APPLICATION FOR EXEMPTION FROM SITE PLAN REVIEW

Project Name/Description

Description of Proposed Development: 27 High St, 04002

### PROPOSED PROJECT

PROPOSED DECK PLAN

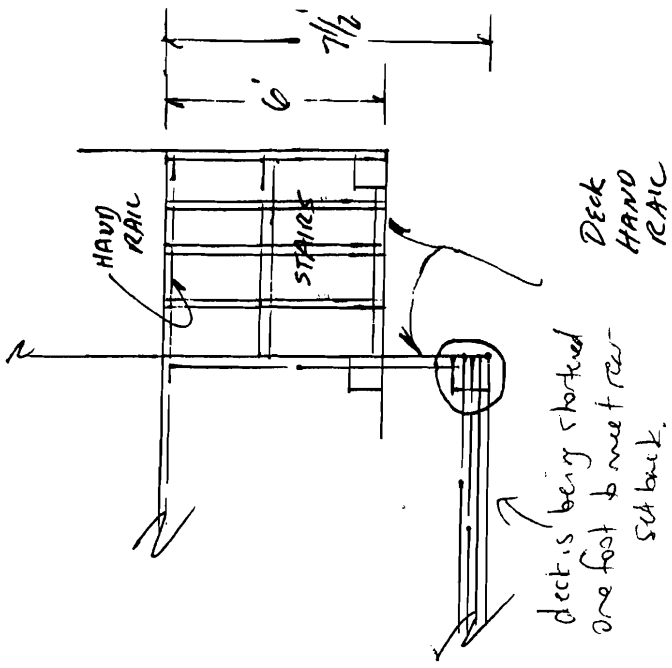
SEE REVISION A

REVISED DECK PLAN A  
NO DSD  $\leq$  10' 0"

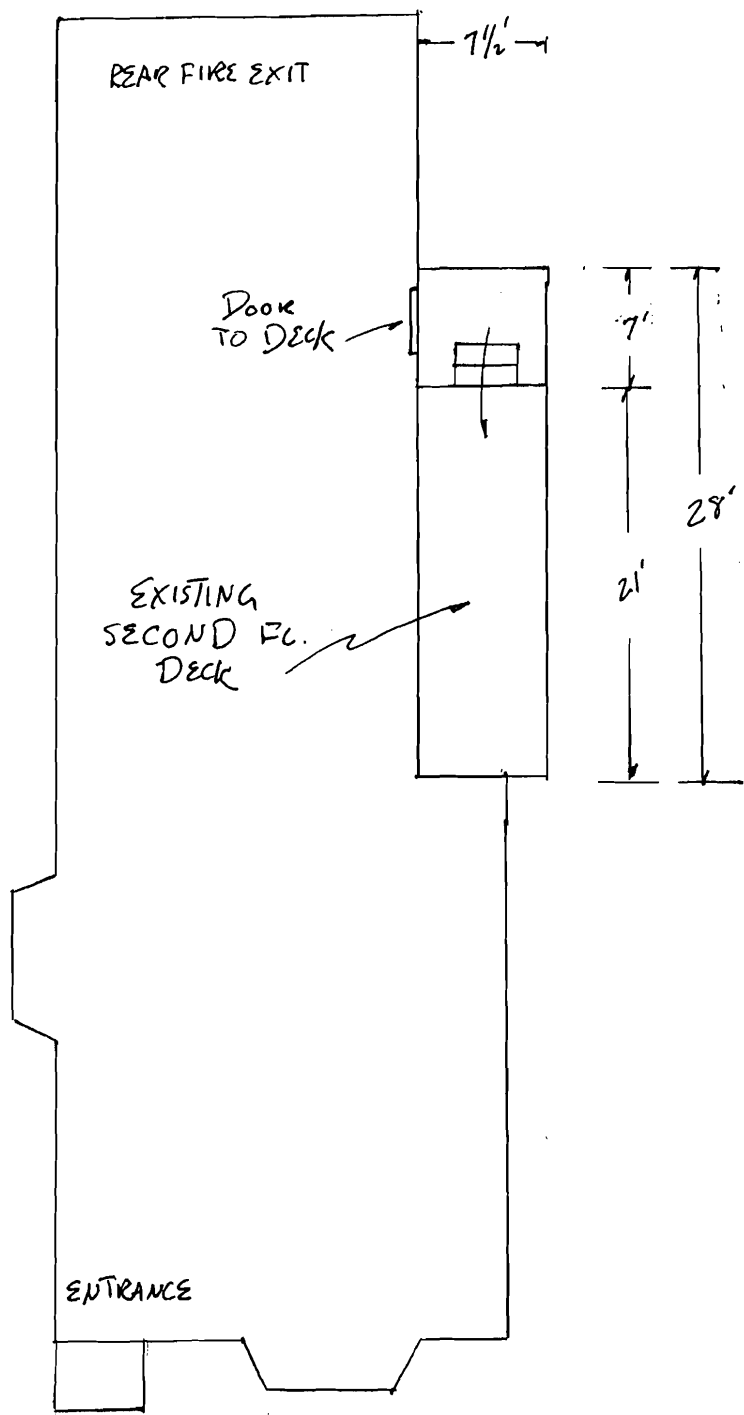
~~adding 12 x 7.5 = 90~~  
 adding 5 x 7.5 = 37.5  
 6 x 4 = 24  
 total 61.5
